Project	IEEE 802.16 Broadband Wireless Access Working Group < http://ieee802.org/16 >	
Title	DL and UL loading parameters information	
Date Submitted	2007-03-08	
Source(s)	Peretz Feder – Alcatel-Lucent Phillip Barber - Huawei Honghai Zhang – Alcatel-Lucent	pfeder@alcatel-lucent.com pbarber@broadbandmobiletech.com hozhang@alcatel-lucent.com
Re:	IEEE 802.16 Session #48 – Phone CBR session	
Abstract	This contribution proposes the updates of IEEE 802.16g D8 document in order to obtain loading information from the Base Station	
Purpose	Update 802.16g draft obtain uplink and downlink loading information	
Notice	This document has been prepared to assist IEEE 802.16. It is offered as a basis for discussion and is not binding on the contributing individual(s) or organization(s). The material in this document is subject to change in form and content after further study. The contributor(s) reserve(s) the right to add, amend or withdraw material contained herein.

DL and UL loading parameters information

Figure 57 – Maintaining downlink synchronization

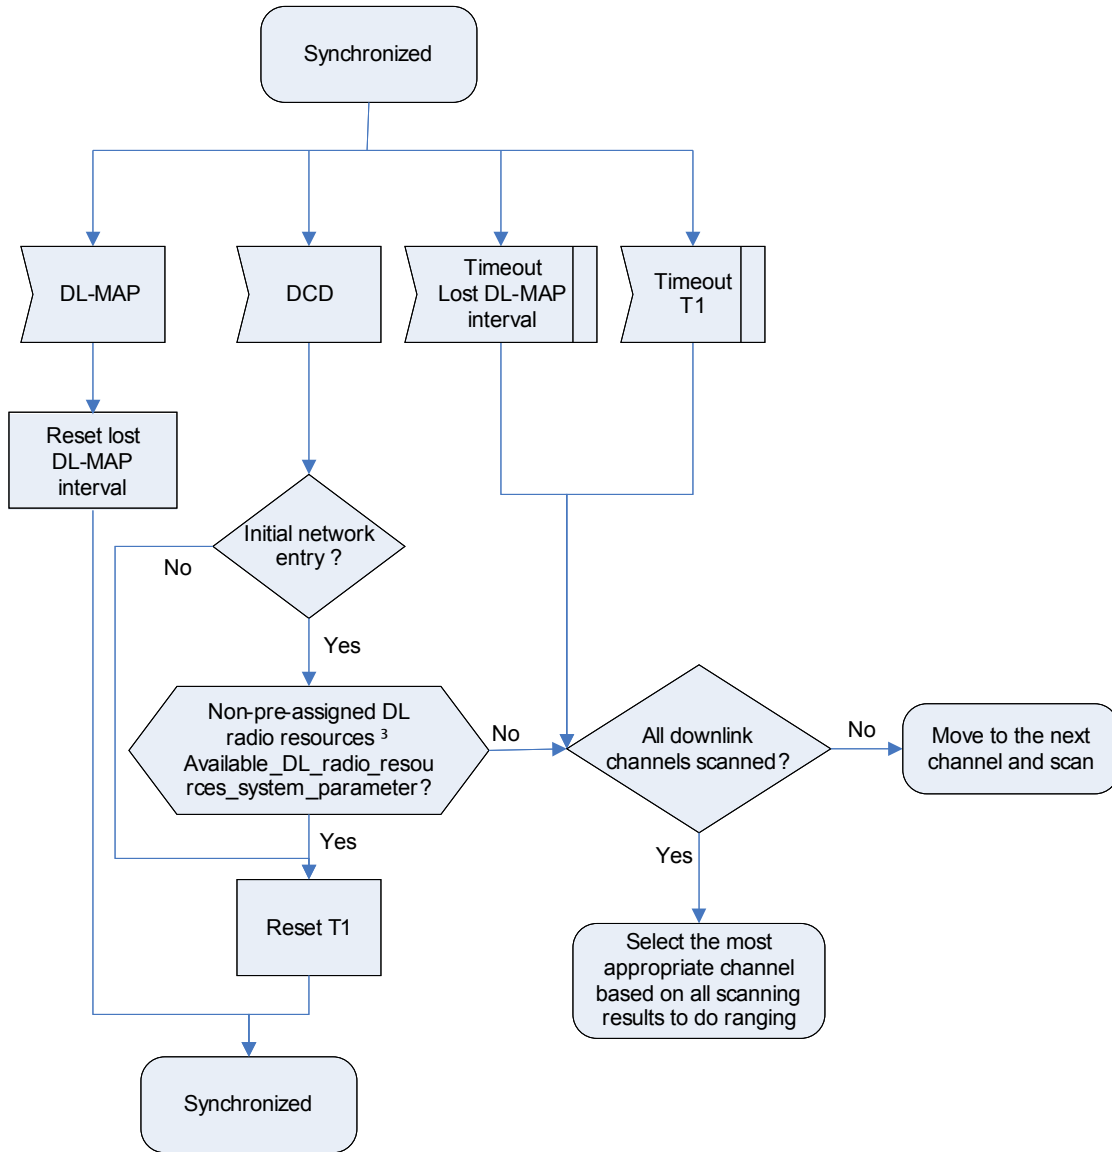
The MAC shall search for the DL-MAP MAC management messages. The SS achieves MAC synchronization once it has received at least one DL-MAP message and is able to decode the DL-Burst Profiles contained therein. An SS MAC remains in synchronization as long as it continues to successfully receive the DL-MAP and DCD messages for its channel **upon network entry only** and the Non-pre-assigned DL radio resources in the DCD message are higher than or equal to the available_DL_radio_resources_system_parameter. If the reported Non-pre-assigned DL radio resources are less than the available_DL_radio_resources_system_parameter, the SS/MS should continue scanning to find another channel until all channels are scanned. If all channels are scanned, the MS should choose the most appropriate channel to perform initial ranging according to section 6.3.9.5 based on conditions that include **RSSI**, CINR and the available Non-pre-assigned DL/UL radio resources of all channels. If the Lost DL-MAP Interval (Table 342) has elapsed without a valid DL-MAP message or the T1 interval (Table 342) has elapsed without a valid DCD message, an SS shall try to reestablish synchronization. The process of acquiring synchronization is illustrated in Figure 56. The process of maintaining synchronization is illustrated in Figure 57. (language change: add MS and SS section to explain better – perform MAC HO function 6.3.25 or 22?. SS initial entry)

(Note to Editor: Need to modify Figure 57 – see below)

Figure 58 – Obtaining uplink parameters

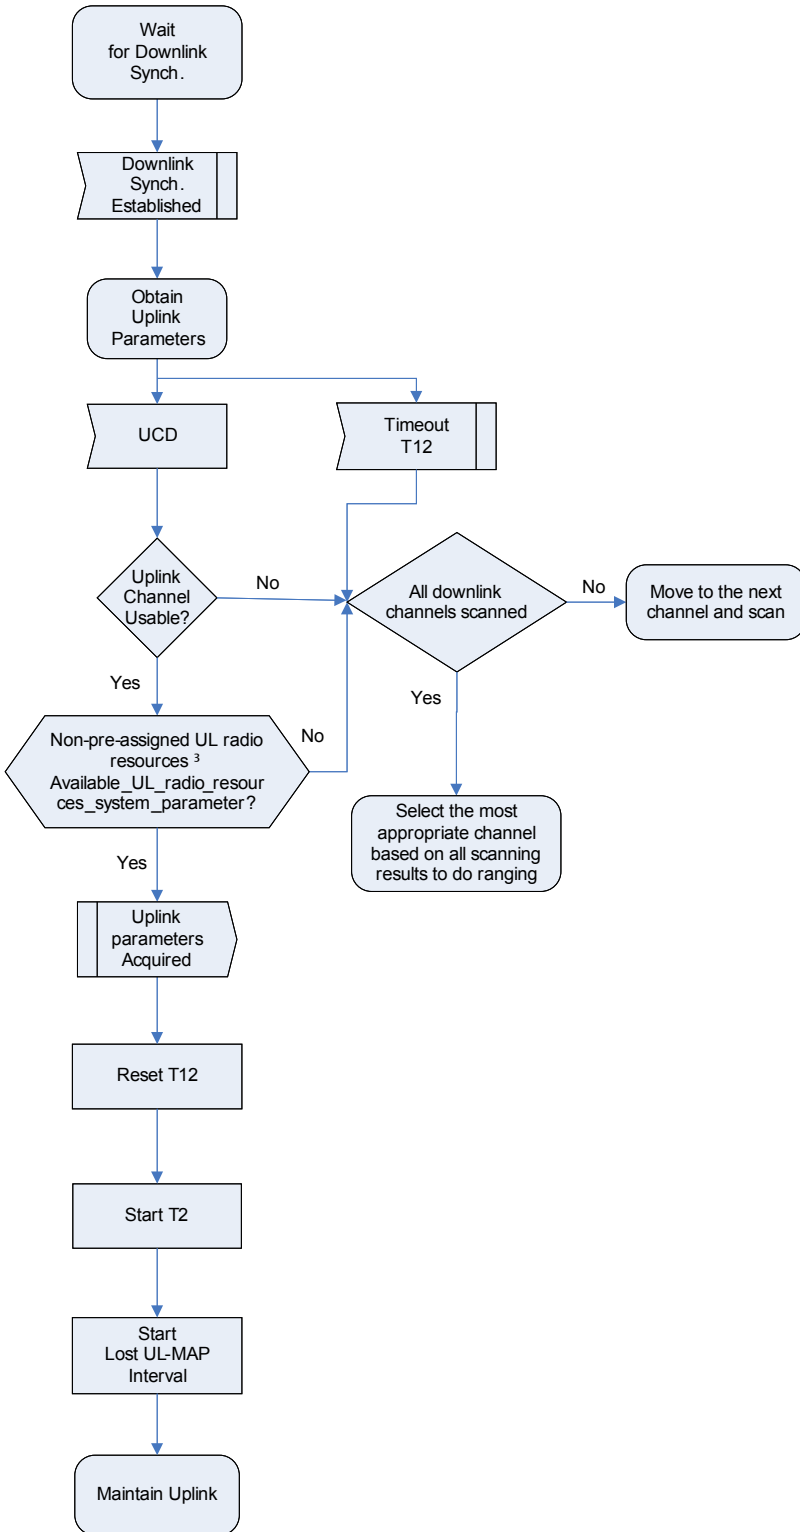
If no uplink can be found after a suitable timeout period, **or if the Non-pre-assigned UL radio resources in the UCD message are lower than the available_UL_radio_resources_system_parameter**, then the SS shall continue scanning to find another downlink channel. The process of obtaining uplink parameters is illustrated in Figure 58. (Editor: need to change Figure 58 – see below)

Figure 59 – Maintain uplink parameters

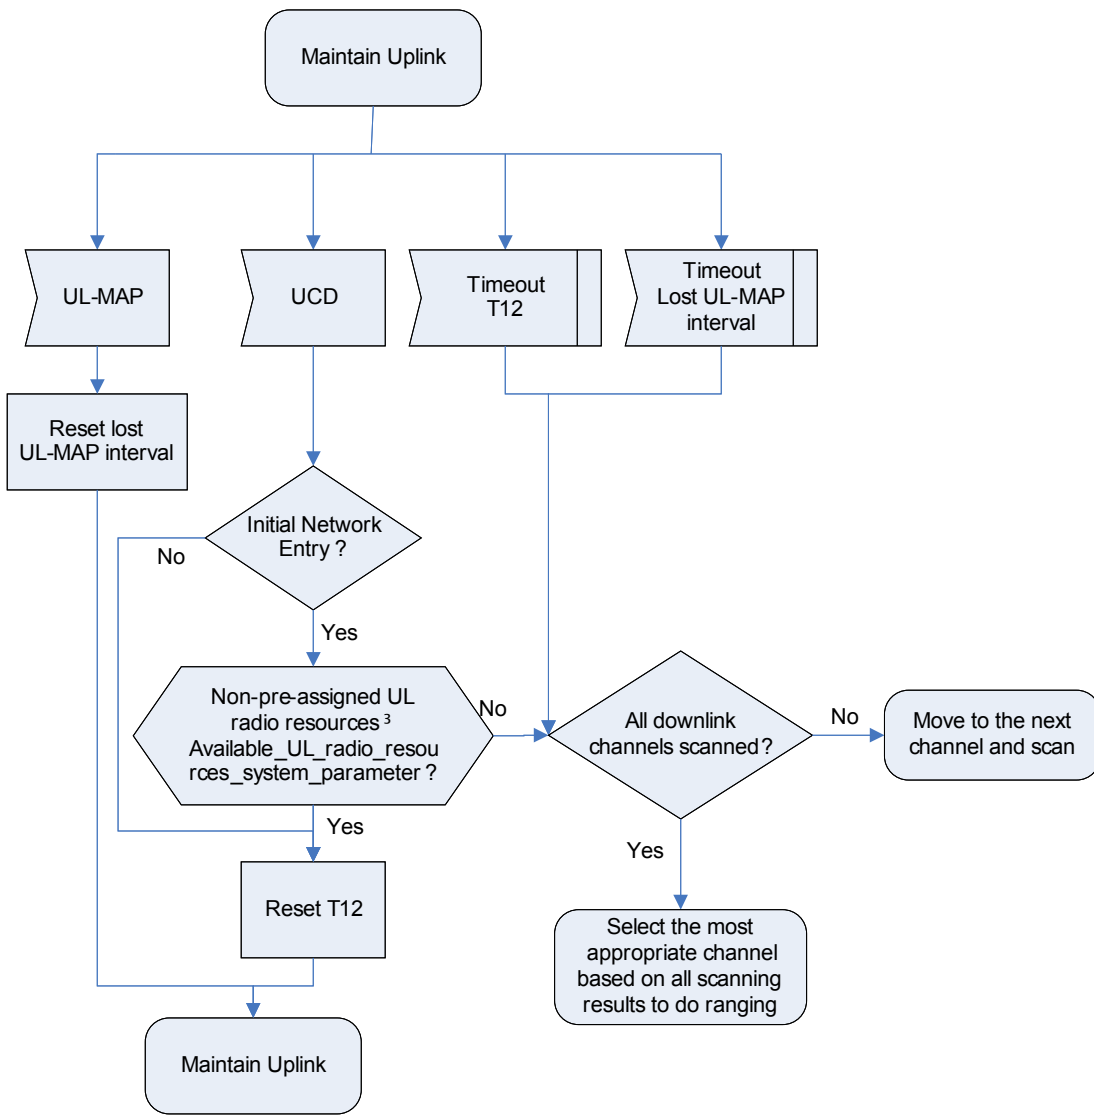
The SS MAC is considered to have valid uplink parameters as long as it continues to successfully receive the UL-MAP and UCD messages. If at least one of the messages is not received within the time intervals specified in Table 342 or the Non-pre-assigned UL radio resources are lower than the `available_UL_radio_resources_system_parameter`, the SS shall not use the uplink. This is illustrated in Figure 59.

(Editor: need to change Figure 59 – see below)
